PLAN REVIEW SHEET

2015-081

Selwyn Property Group Investments, LLC

Bus stop pad detail

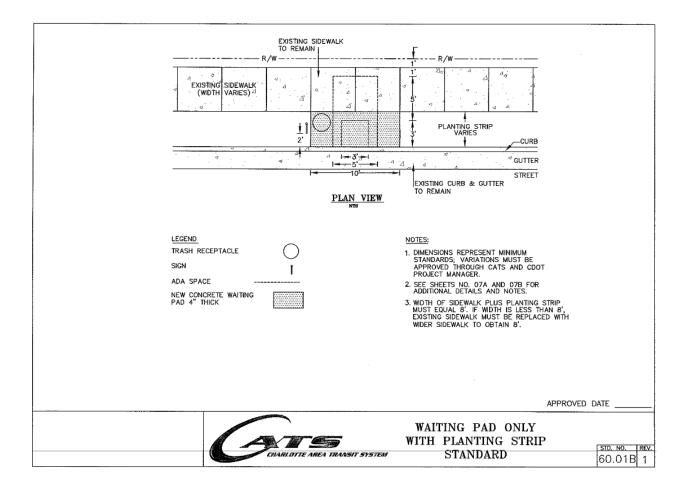
The Petitioner is requested to provide and construct a concrete pad for the existing bus stop. Below is an image of the standard detail (60.01B) for the requested concrete pad. The site plan may either show the conceptual location of the improved bus stop on Kenilworth Avenue, or alternatively, include a development note to locate the bus stop pad during the urban review process.
